ADDENDUM NO. 2

RE: ADDENDUM NO. 2 PARK AVENUE SIDEWALKS IMPROVEMENT PROJECT BIDS DUE JUNE 19, 2019 AT 3:00 P.M.

City of Capitola, California

Revised/Additional Plan Sheets Provided: L-5, L-6, CD-3, CD-7, DR-2, RW-1, SS-5, SS-6

CROSS-SECTIONS										
FOR	REF	ERENCE	ONLY							
NOT	FOR	CONSTR	UCTION

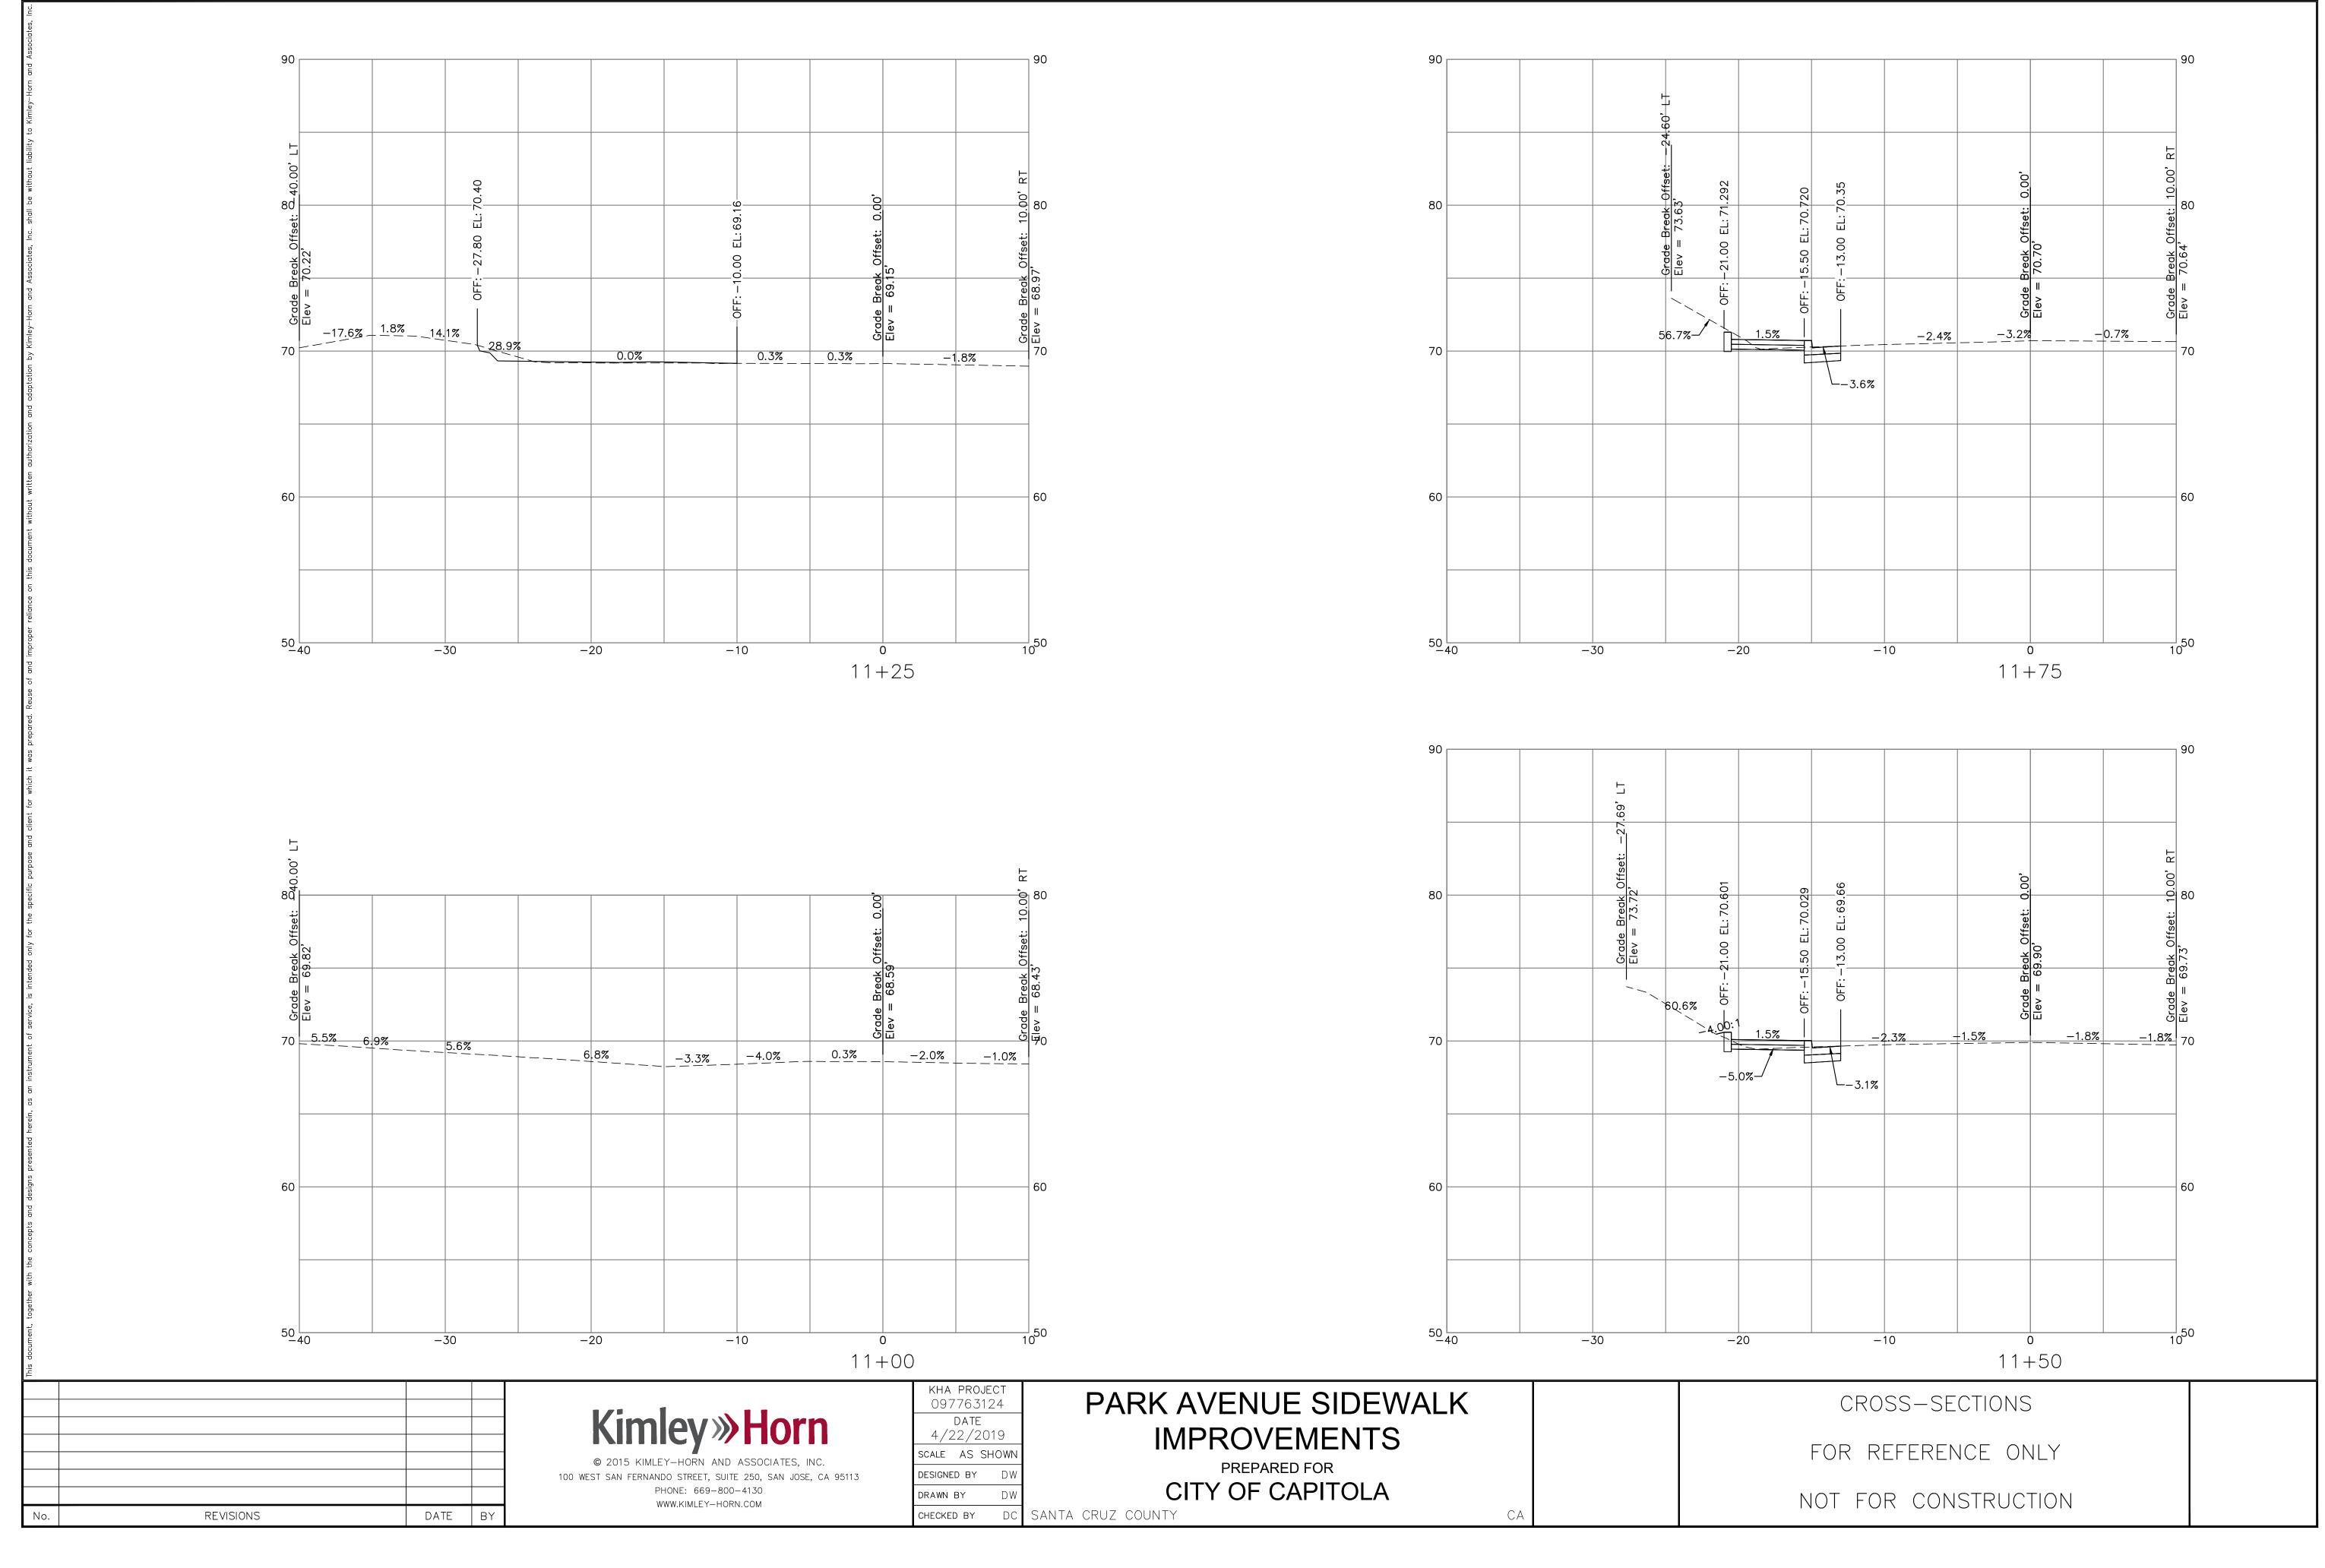
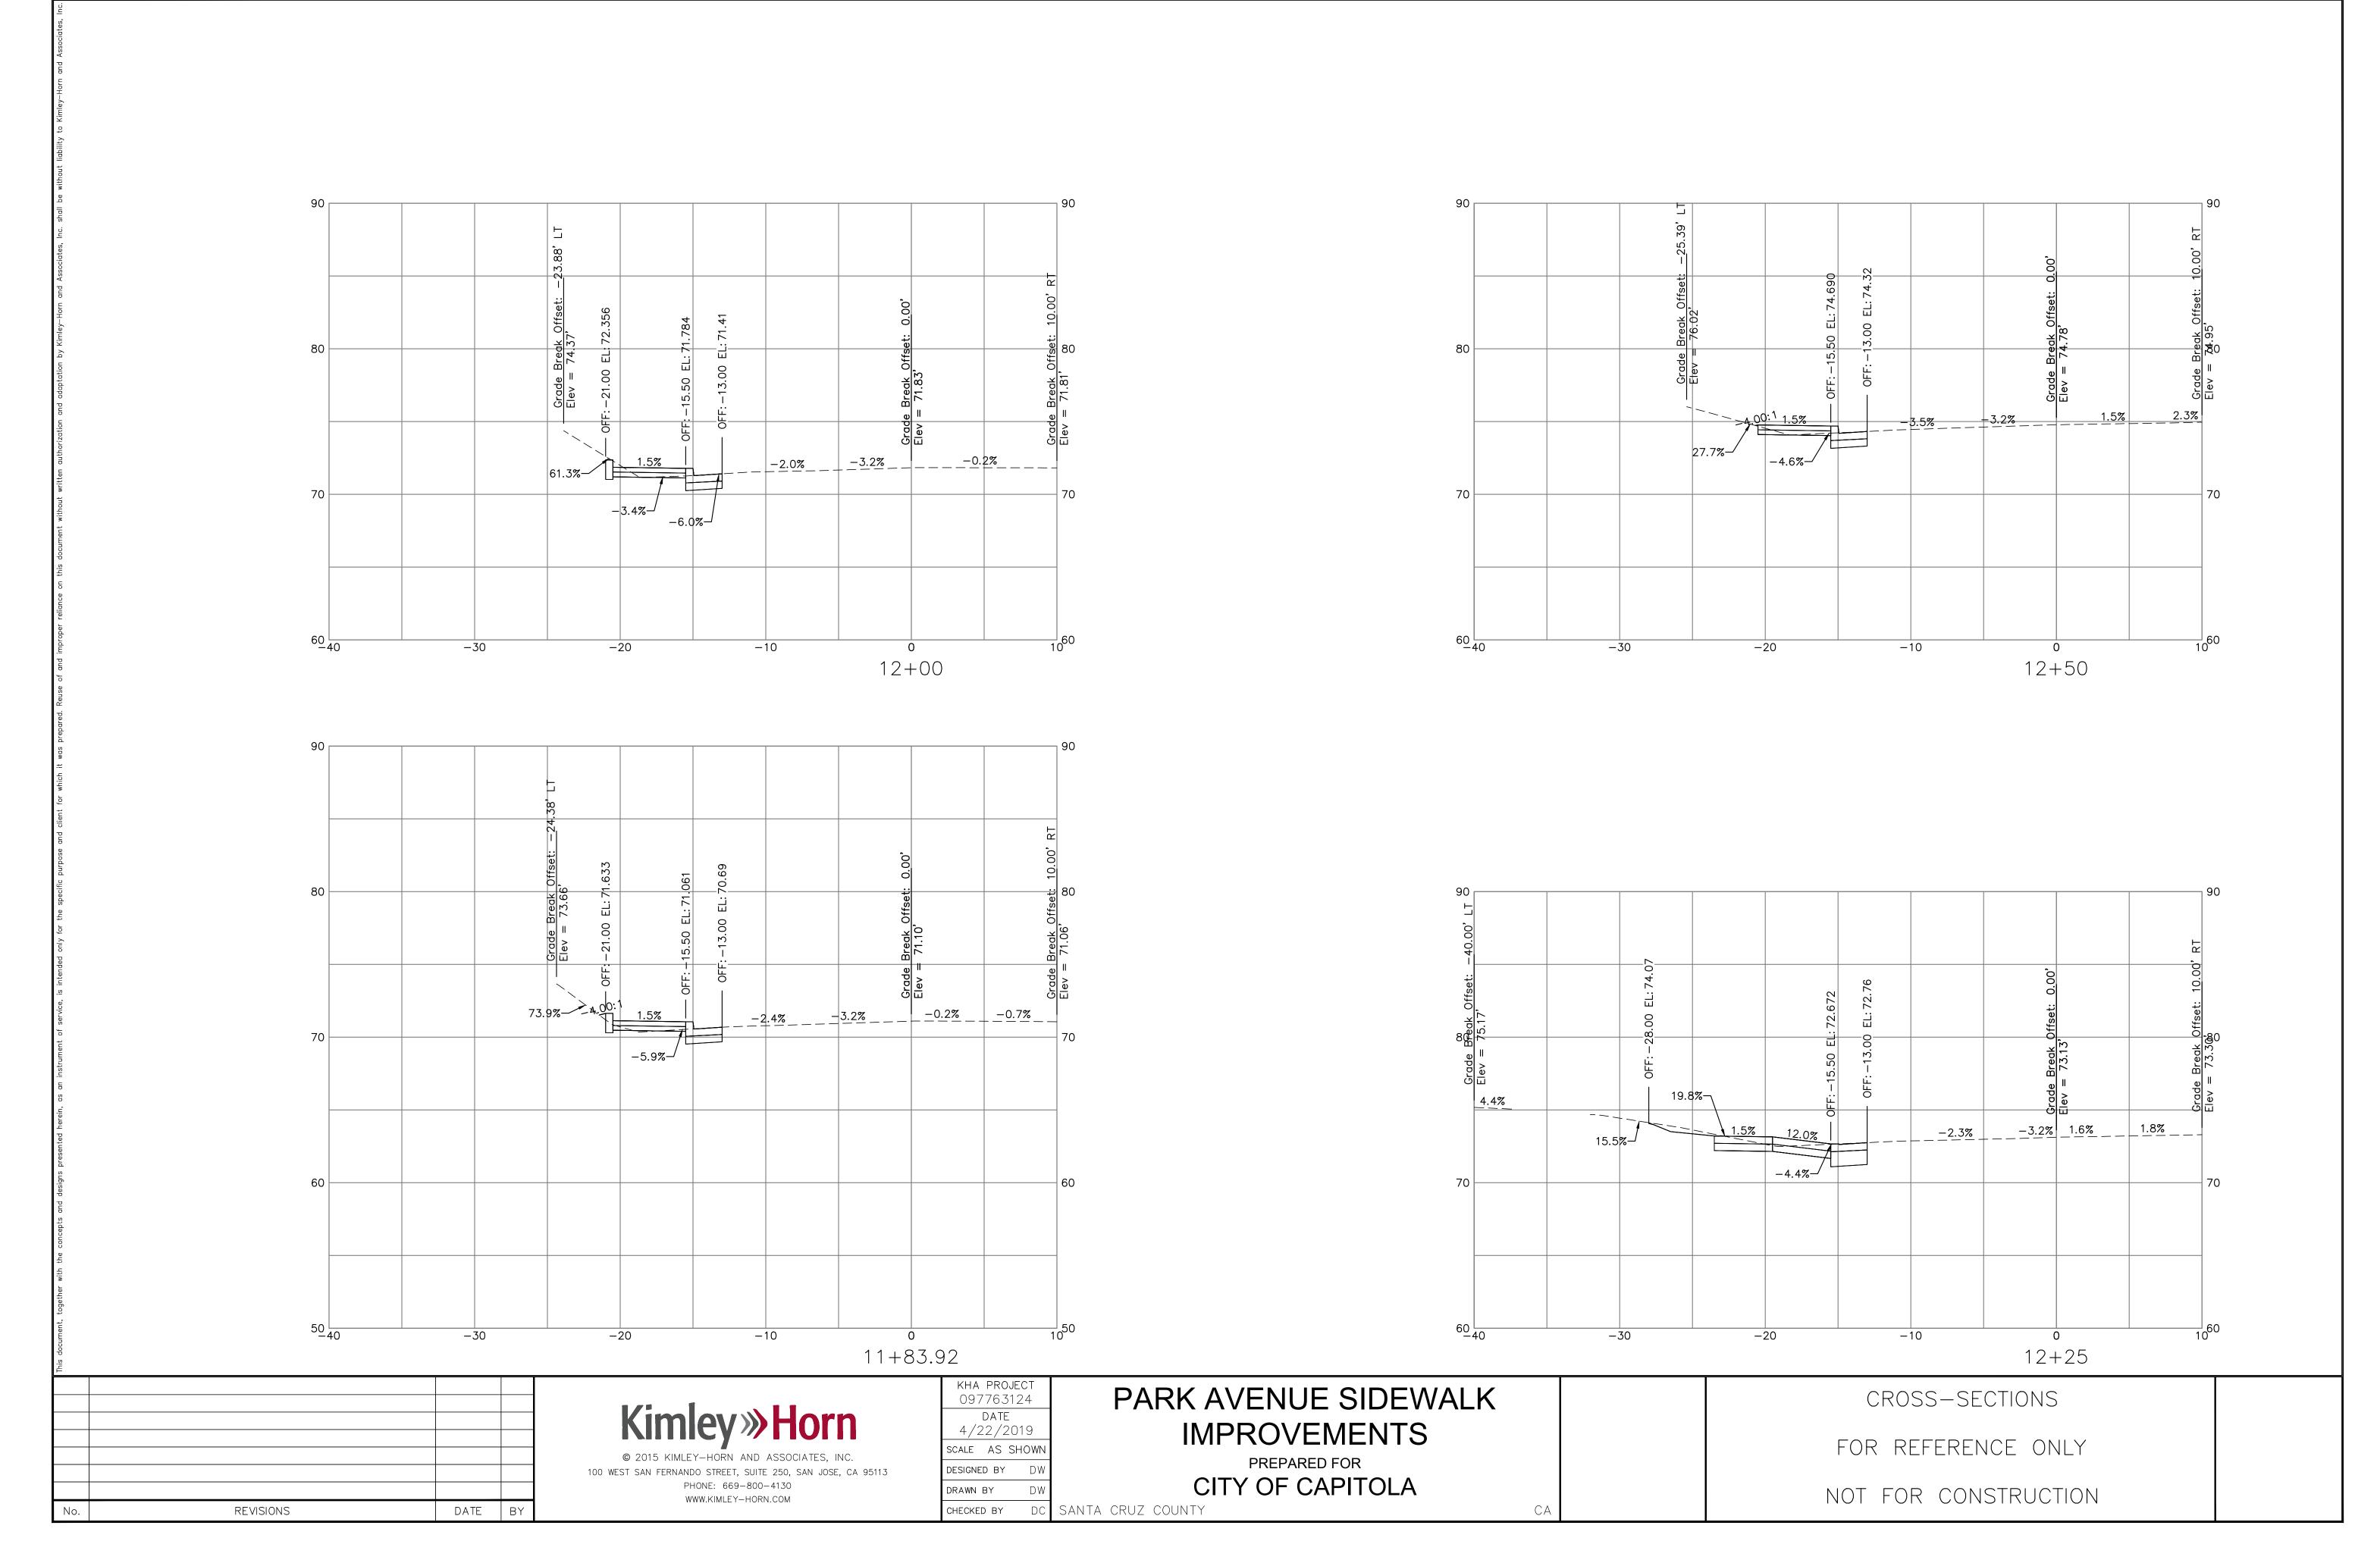
- 1. Cut and fill quantities
 - a. New cross-section details provided as 22 sheets (Addendum 2 Bid Item 18 Roadway Excavation Cross Sections)
